From: Peter Bull <Peter.Bull@north-herts.gov.uk>
Sent: 31 July 2026 06:24:25 UTC+01:00
To: "ConsulteeComments" <ConsulteeComments@north-herts.gov.uk>
Subject: FW: LG3 - conditions

Senior Transport Officer – 26/00364/DOC

Regarding 26/00364/DOC, this plan provides all the details we require:
[HA378-CDP-XX-XX-DR-AR-001900-C07-SITE EXTERNAL WORKS LAYOUT](#)

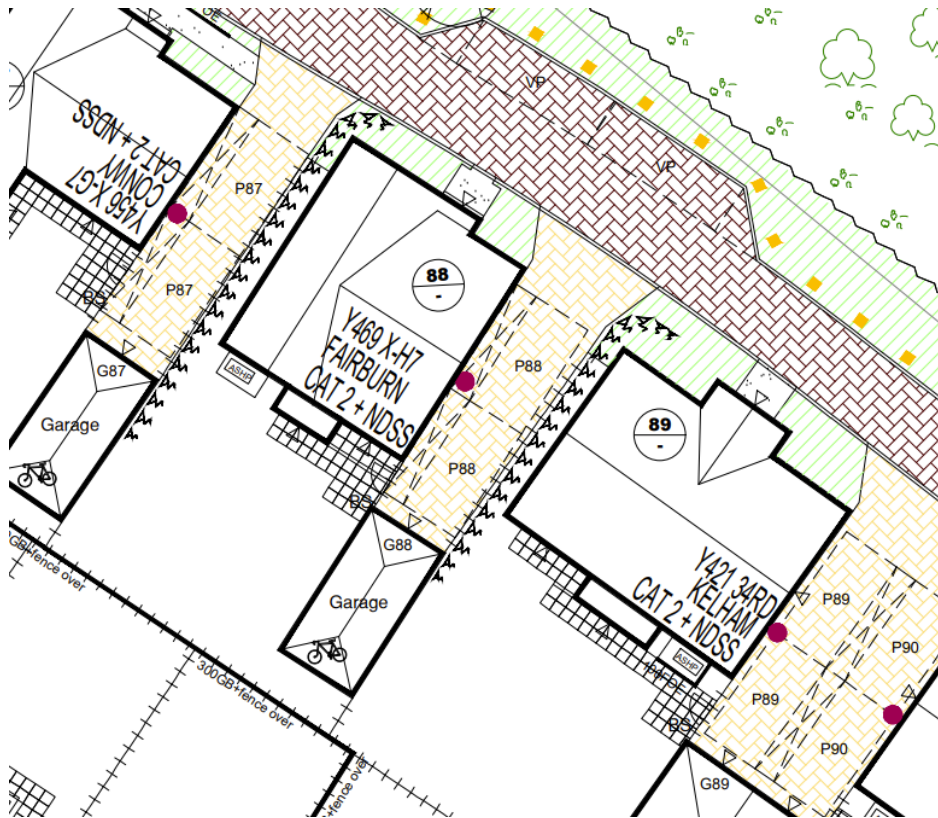
In general, parking bays should be adjacent to EV charge points to avoid obstructing the route between garages (cycle parking) and bin stores and the street when a car is on charge (e.g. P87 and P88 should mirror P89).

In some cases, a car parked in the bay closest to the garage would block access to the garden gate, which would also obstruct movement between the bin store and the street (P87 and P88). In these cases the gate will need to be moved back and/or the parking bays shown further back to demonstrate that there is sufficient space.

Where the passageway through the driveway is shared (e.g. P89), it should be paved in a contrasting material to encourage both neighbours to leave enough space for access. (I don't think the District Design Code covers shared driveways.)

We shouldn't have charging cables running across front paths, especially for P37 and P38, where a cable would obstruct wheeled access. The chargepoints should be on posts in front of the parking bays.

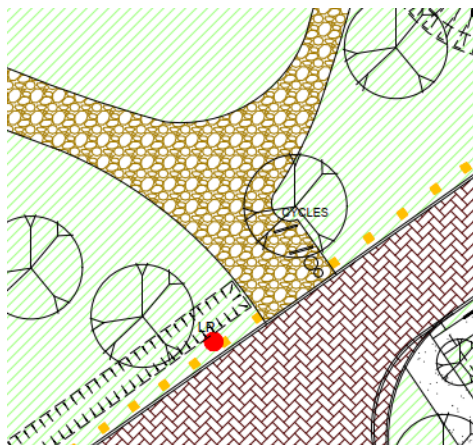
The cycle racks shown here are in the most conflicted space, and should be located in place and configuration that doesn't pinch the shared-use path below 3m. The footpath off to the right doesn't need such a flared junction with the shared-use path, so the cycle parking could perhaps be integrated into this.
